TENDER 16-20

WATER TREATMENT BUILDING

ADDENDUM NO. 8

October 20th, 2016

TITLE: PROPOSED RAW WATER SUPPLY MAIN HIGHWAY #28 TREATMENT BUILDING - CONTRACT 2	DRAWING NO. 15-508- C202
JOHN HART WATER QUALITY CENTRE WATERMAIN TIE-IN DETAILS	PROJECT: 112311316
	REV. 3

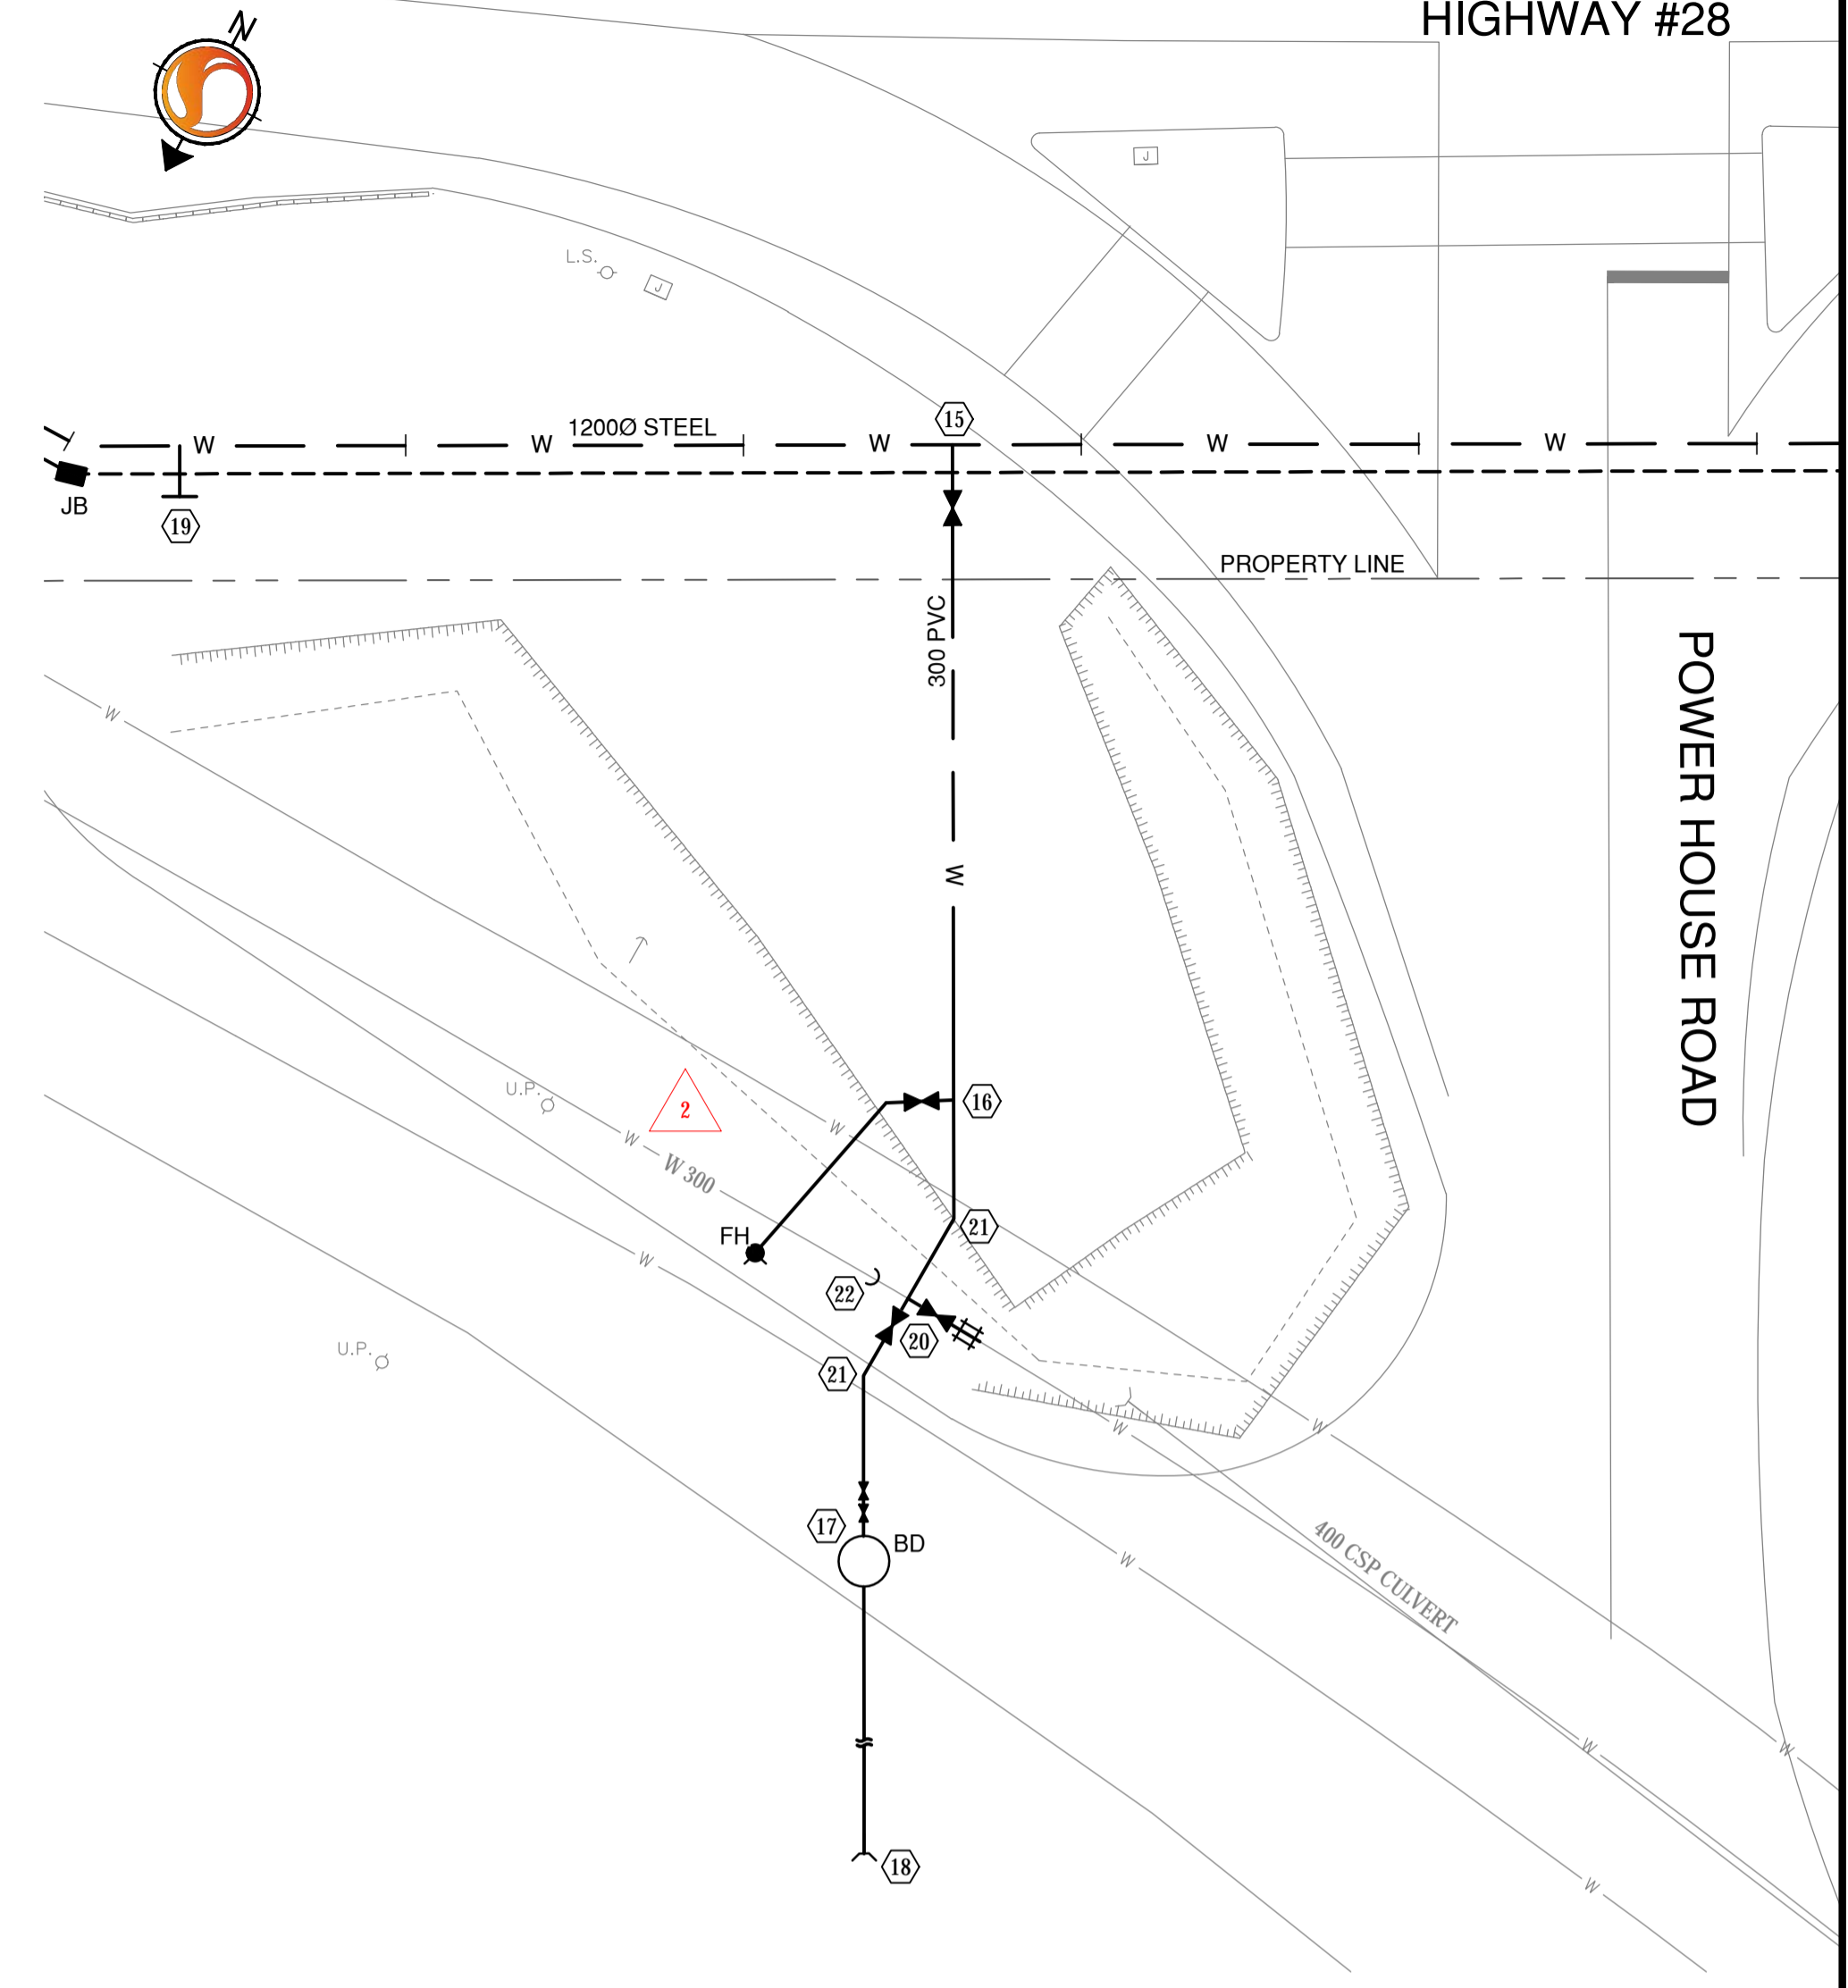
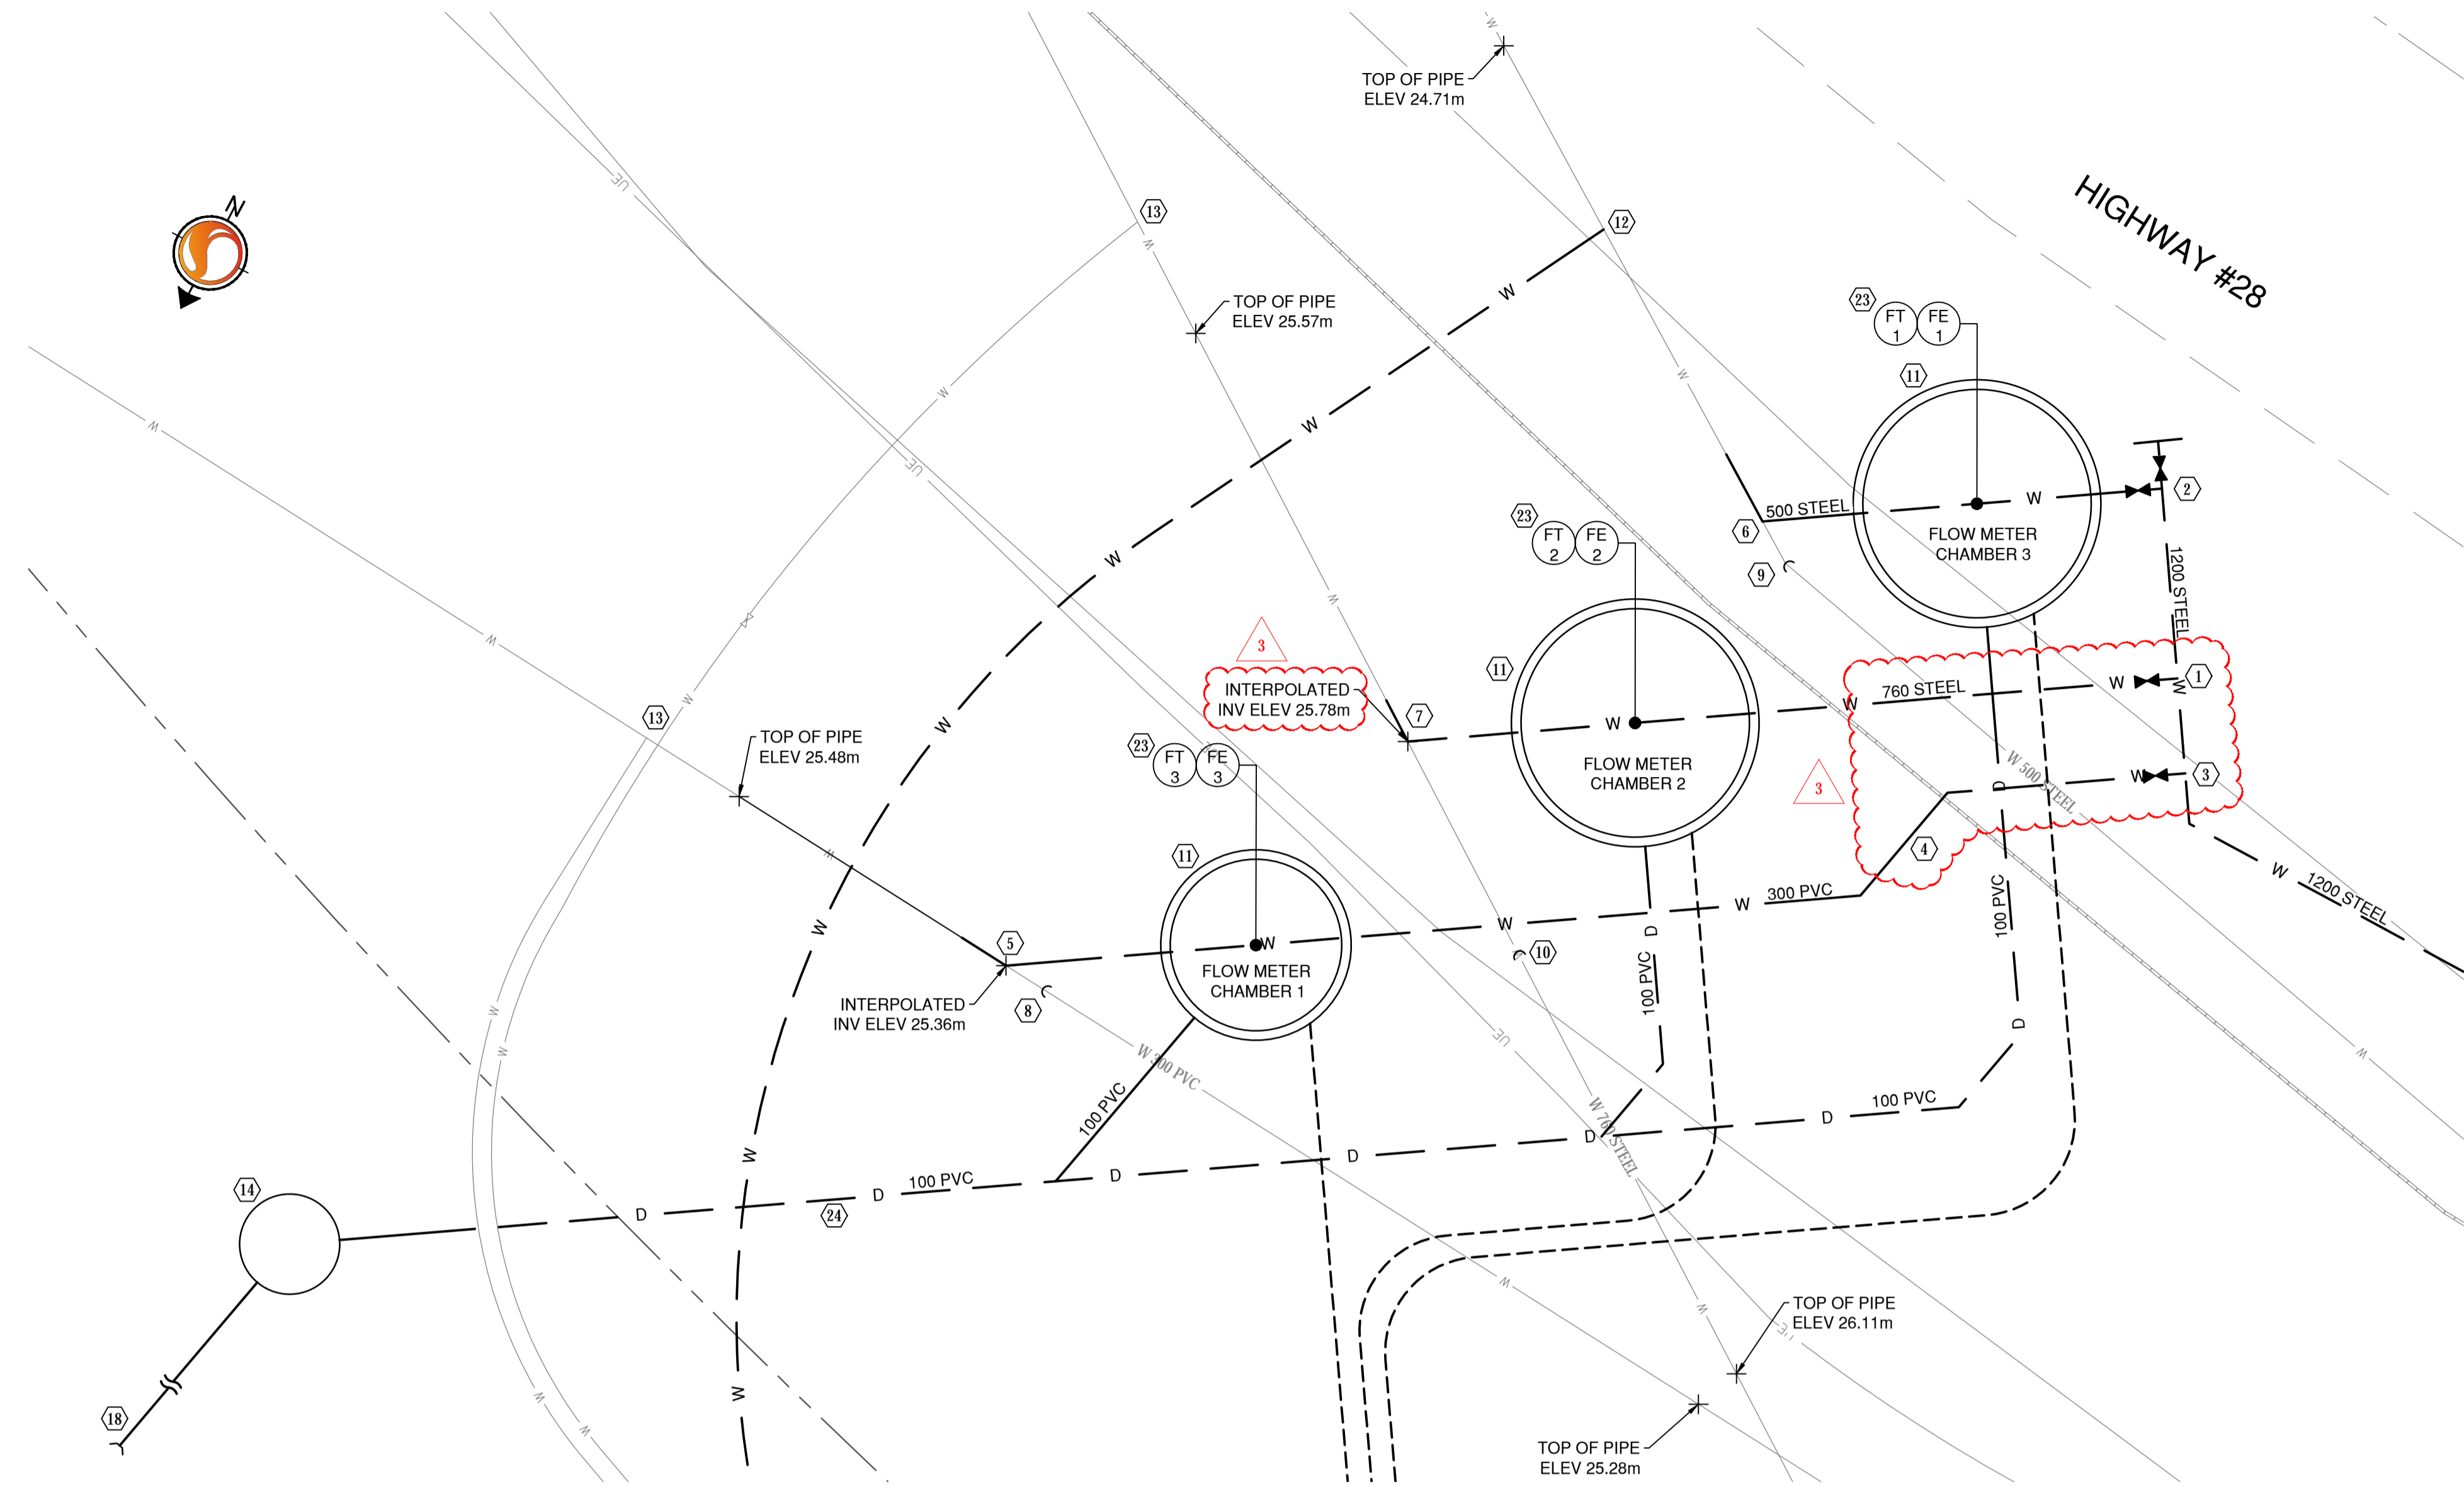
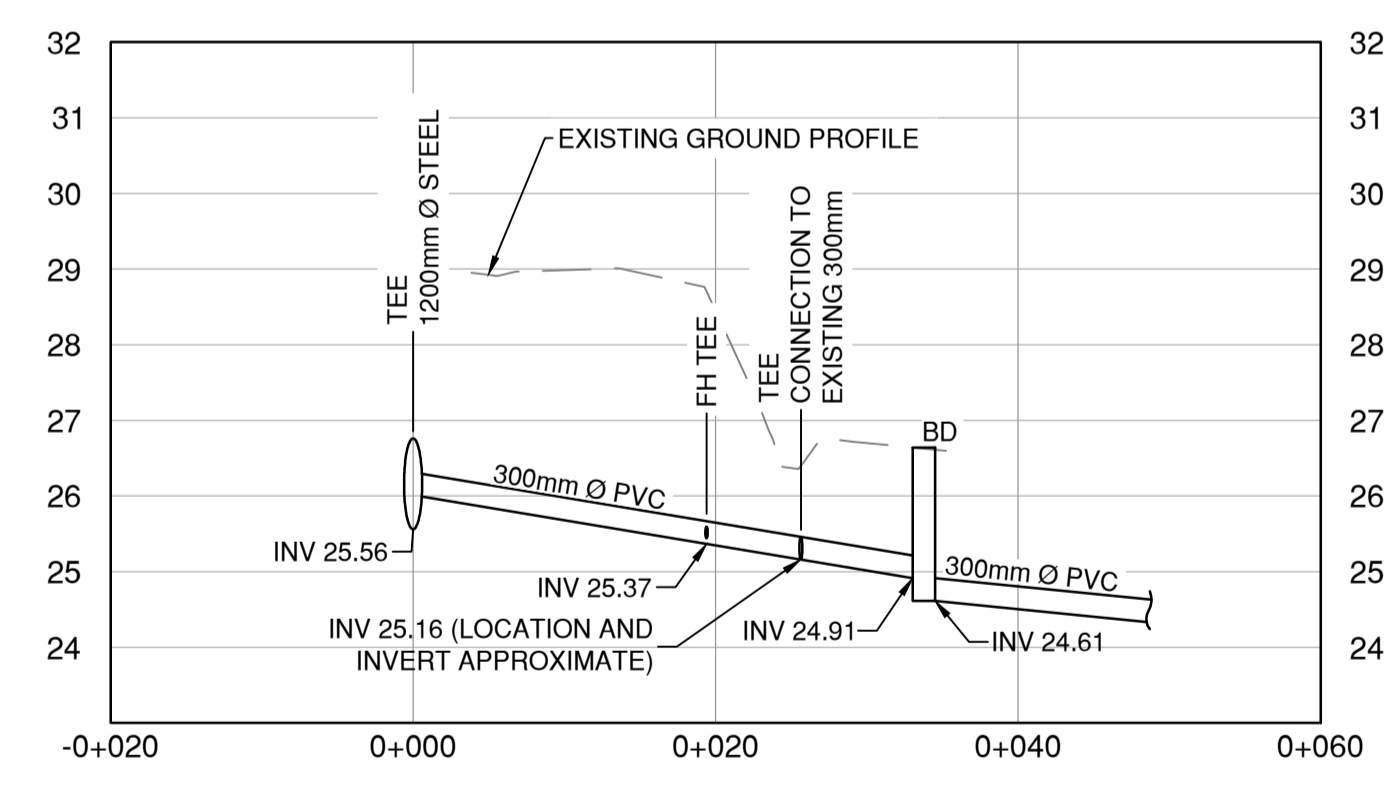
With reference to drawing C202, Rev 2 which shows elevations on the tops of certain existing pipes, and interpolated invert elevations, could you please confirm the indicated elevation of 25.48 at Note 7 is correct. We calculate it to be 25.02.

What is critical for the first tie-in, which is the 500mm, is to determine whether the 900 branch will pass over the existing 500mm upstream of the connection point. Please confirm that the 900 is to pass over top of the 500.

Interpolated invert elevation at note 7 on C202 should be 25.78m

See revised layout on attached drawings C201 and C202. Valve on 760mm diameter line has been moved to the south west side of the 500mm dia. Main to allow the tie in to be isolated without needing to cross the 500mm diameter line. The 500mm diameter line can then be abandoned at the point where the 760mm dia. line crosses.
